MANDATORY SERVICE BULLETIN

EFFECTIVITY: BELL 206 & 206L SERIES HELICOPTERS EQUIPPED WITH AIRFILM CAMERA SYSTEMS G1 UTILITY MOUNT

SUBJECT: MANDATORY INSPECTION AND MODIFICATION OF NOSE CONSOLE AT G1 MOUNT FASTENERS

DATE: 1/05/2015

Figure 1 G1 Mount Fastener Locations

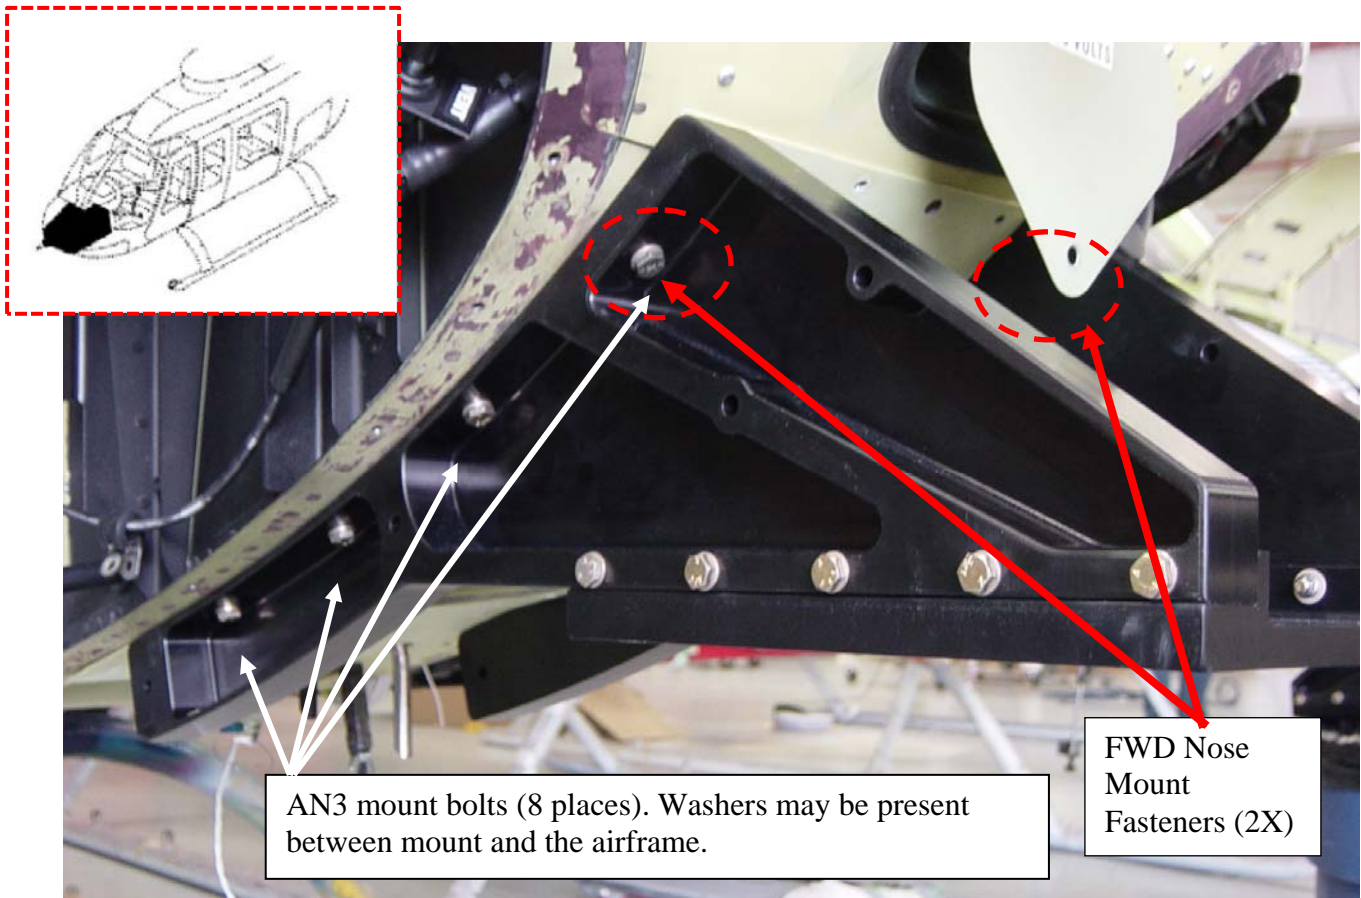
- (1) Remove G1-1 Utility Mount to gain access to the Internal Nose Console (airframe) by removing the 8 AN3 mounting bolts on the outboard upper flanges of the G1 Mount. Reference Install Instruction (AF-G1-006) for detailed description of removal procedures.

Washers may be present as shims between G1 mount and airframe. Note the location and quantity of the shims for reinstallation.

Figure 2 View (looking Down) Showing the LH Side Forward Fastener with Crack Damage

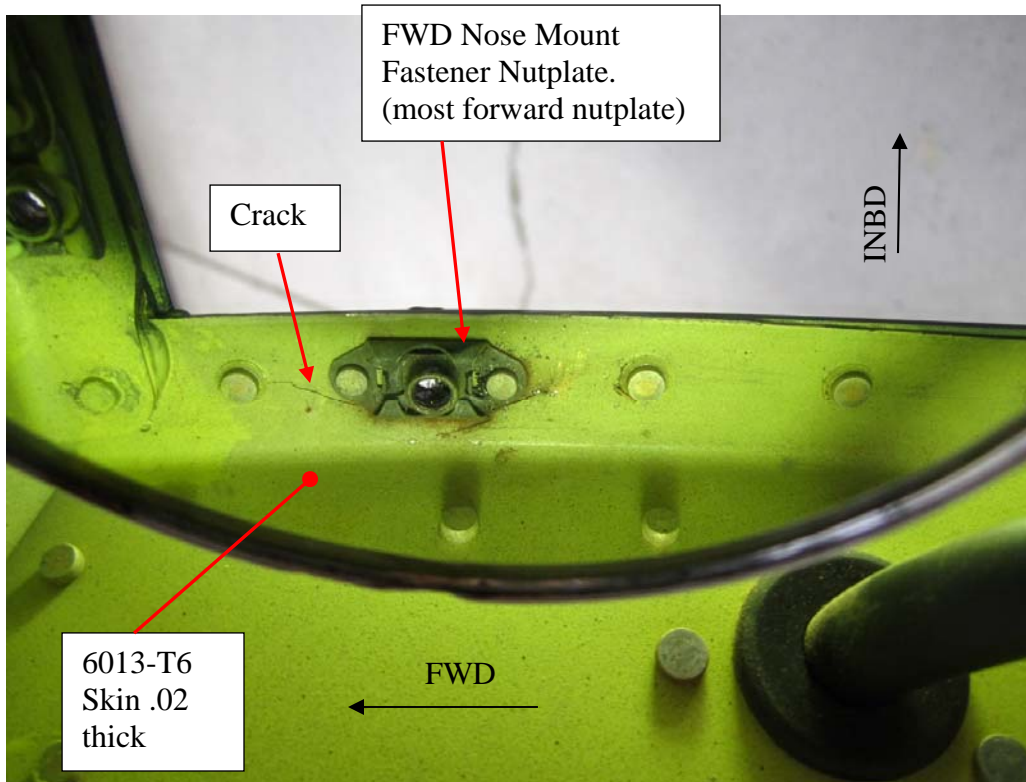
- (3) Inspect for cracks in the Nose Console area at the G1 mount forward fastener nutplates (RH & LH sides). Figure 3 shows a typical crack near the nutplate at the radius of the formed flange.

Use 10X magnified visual inspection or fluorescent penetrant inspection (per ASTM E1417) to inspect for cracks in the areas noted.

Figure 3 View Showing the Repair Fitting Installed (RH Side)

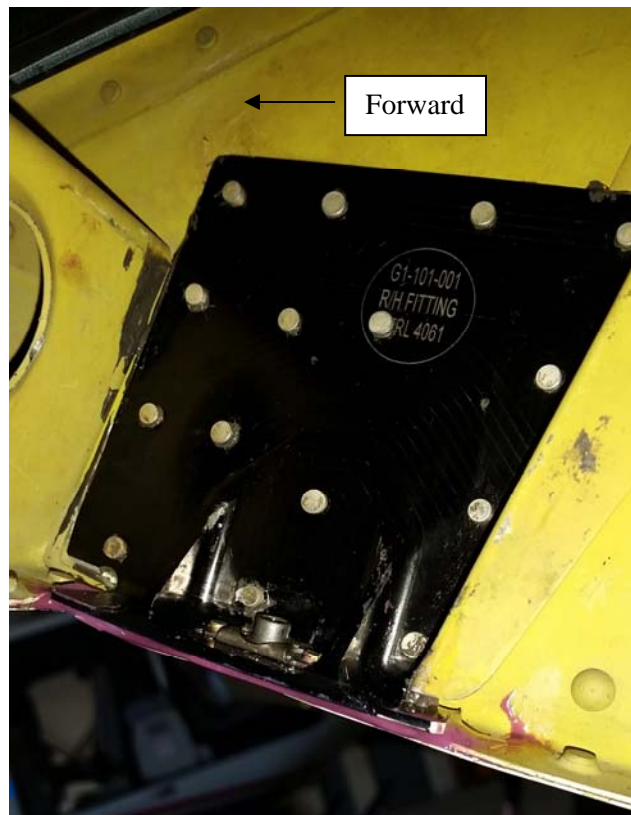
- (4) If no cracks are found, proceed to step 5. If cracks are present, repair in accordance with Airfilm Drawing AF-G1-300.

If any cracks or loose rivets are found during this inspection, the aircraft must be repaired before returning to service.

If the damage is outside the maximum damage criteria defined in the repair drawing, contact Airfilm Camera Systems for Engineering Support.

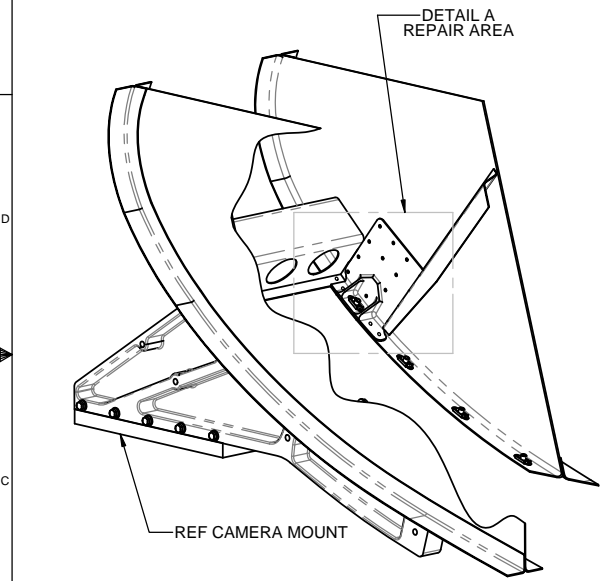
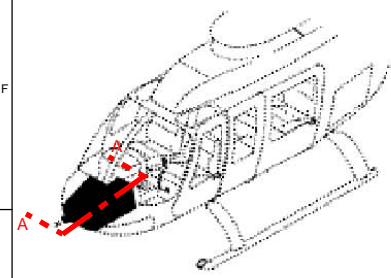
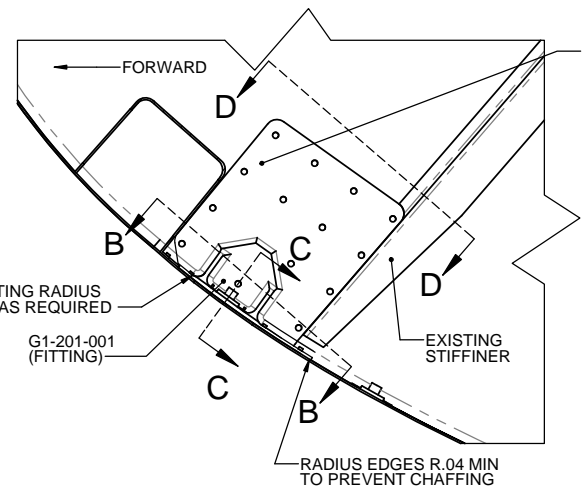
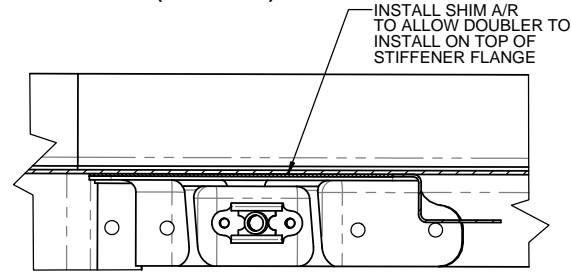
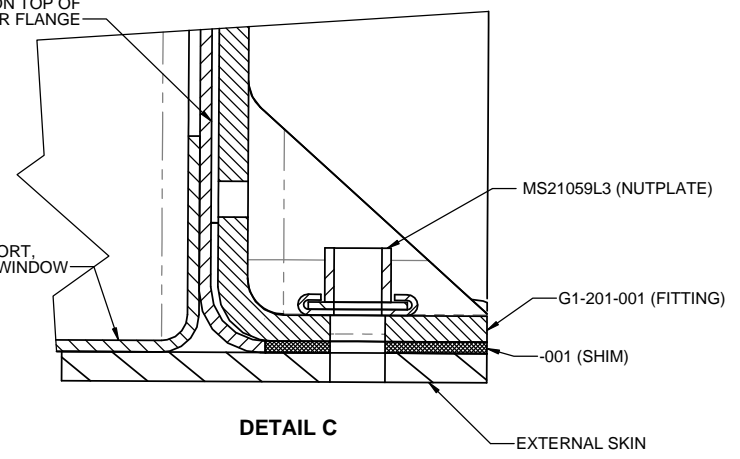
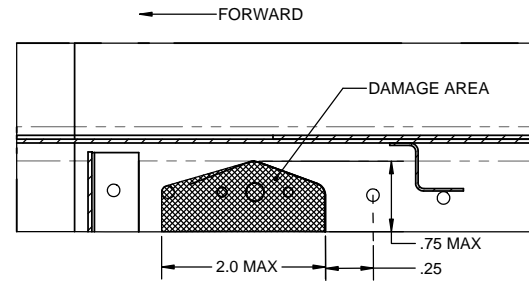
1. REMOVE RIVETS IN REPAIR AREA
2. REMOVE DAMAGED FLANGE BY CUTTING/GRINDING.
3. ALL INTERNAL RADII .125 MIN.
4. POLISH CUT SURFACES, 63 RHR MAX (MILL FINISH).
5. INSPECT DAMAGE AREA AND ADJACENT RIVET HOLES USING 10X MAGNIFIED VISUAL INSPECTION OR FLUORESCENT PENETRANT (PER ASTM E1417).
6. FABRICATE SHIM FROM .016 THICK 2024-T3 CLAD PER AMS-QQ-A-250/5.

7. TRIM REPAIR FITTING AS REQUIRED TO CAPTURE THE REQUIRED NUMBER OF FASTENERS AND MAINTAIN 2D EDGE DISTANCE ON ALL FEATURES.
8. LAYOUT NEW REPAIR FASTENERS APPROX AS SHOWN ⊗. MAINTAIN A MINIMUM OF 2D EDGE DISTANCE ON ALL FEATURES. MINIMUM 6 FASTENERS ON EITHER SIDE OF DAMAGE AREA
9. DRY FIT REPAIR FITTING AND SHIM.
10. MATCH DRILL FASTENER HOLES INTO DOUBLER, SHIMS, AND SKIN.
11. DEBURR ALL HOLES.
12. TREAT EFFECTED AIRFRAME AND REPAIR COMPONENTS FOR CORROSION PREVENTION IAW BTH-ALL-SPM.
13. INSTALL SHIMS, REPAIR FITTING, AND RIVETS WET WITH CORROSION INHIBITING SEALANT (P/S 890 OR EQUIVALENT).
14. USE MS20426AD4 RIVETS FOR FLUSH INSTALLATION ON THE EXTERIOR AND MS20470AD4 (OR CR3213-4) RIVETS IN WEB.

SPOTFACE REPAIR FITTING RADIUS FOR RIVET BUCKTAIL - AS REQUIRED

INSTALL SHIM A/R TO ALLOW DOUBLER TO INSTALL ON TOP OF STIFFENER FLANGE

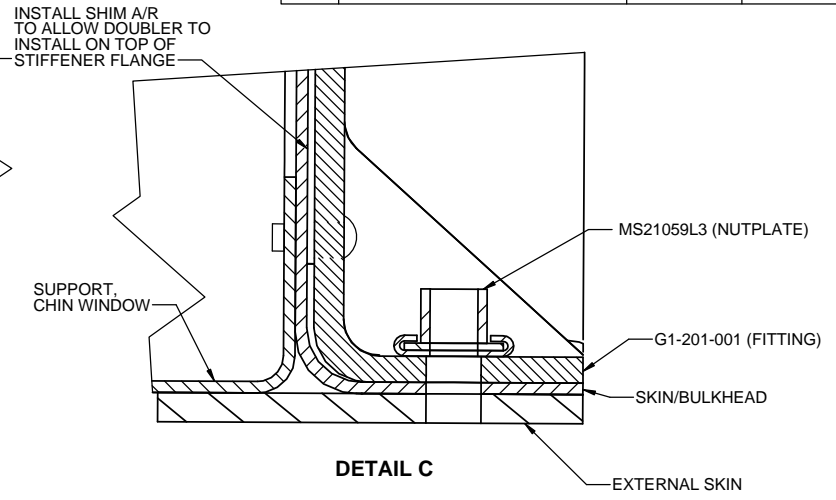
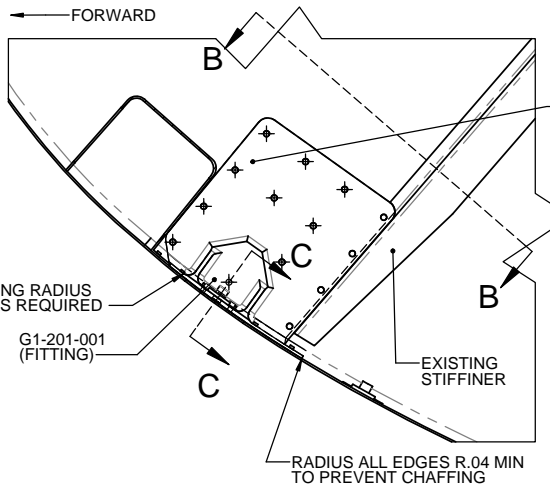
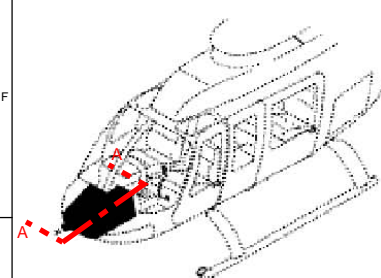
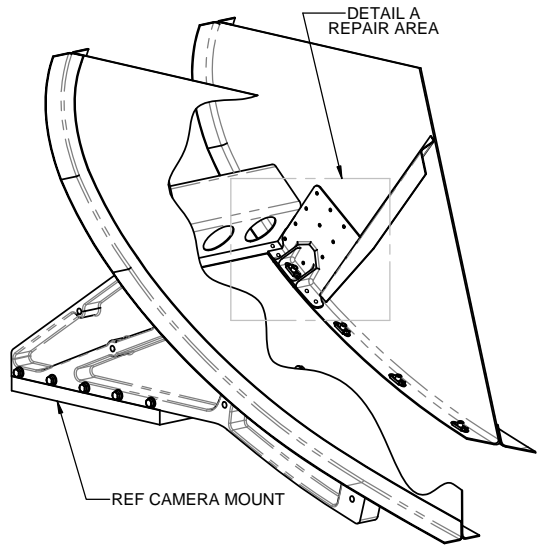
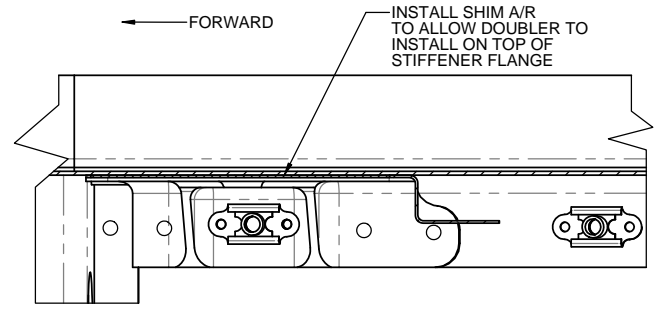
- NOTES:
- TRIM REPAIR FITTING AS REQUIRED TO CAPTURE THE REQUIRED NUMBER OF FASTENERS AND MAINTAIN 2D EDGE DISTANCE ON ALL FEATURES.
 - FABRICATE SHIM FROM 2024-T3 CLAD PER AMS-QQ-A-250/5 (SAME THICKNESS AS STIFFENER).
 - LAYOUT NEW REPAIR FASTENERS APPROX AS SHOWN . MAINTAIN A MINIMUM OF 2D EDGE DISTANCE ON ALL FEATURES. MINIMUM 6 FASTENERS ON EITHER SIDE OF DAMAGE AREA DRY FIT REPAIR FITTING AND SHIM.
 - MATCH DRILL FASTENER HOLES INTO DOUBLER, SHIMS, AND SKIN.
 - DEBURR ALL HOLES.
 - TREAT EFFECTED AIRFRAME AND REPAIR COMPONENTS FOR CORROSION PREVENTION IAW BTH-ALL-SPM.
 - INSTALL SHIMS, REPAIR FITTING, AND RIVETS WET WITH CORROSION INHIBITING SEALANT (P/S 890 OR EQUIVALENT).
 - USE MS20426AD4 RIVETS FOR FLUSH INSTALLATION ON THE EXTERIOR AND MS20470AD4 (OR CR3213) RIVETS IN WEB.

SPOTFACE REPAIR FITTING RADIUS FOR RIVET BUCKTAIL - AS REQUIRED
